Source: Prestolite Leece-Neville Heavy Duty Systems
Bulletin No: TSB-1225 **Date:** December 15, 2023
Models: MDA3927 MDA3929
Subject: Terminal identification to AVI143J3004E

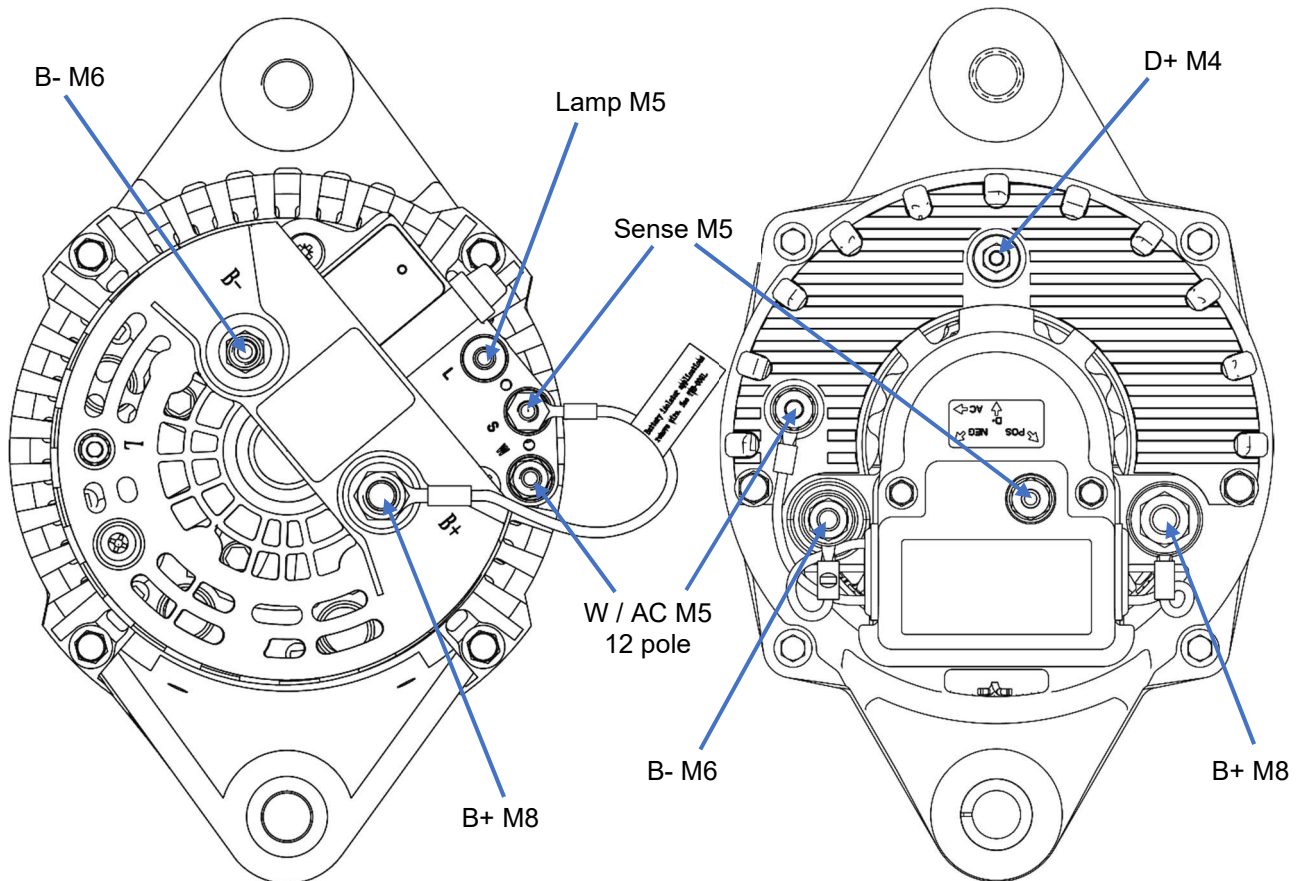
This document will help identify terminal location variances.

⚠ AVI143J3004E has internal cooling fans.
External fan used on the original alternator is not needed.

Both original and replacement AVI143 are self-excite alternators.
See TWB-0091 to wire AVI143J3004E alternator.
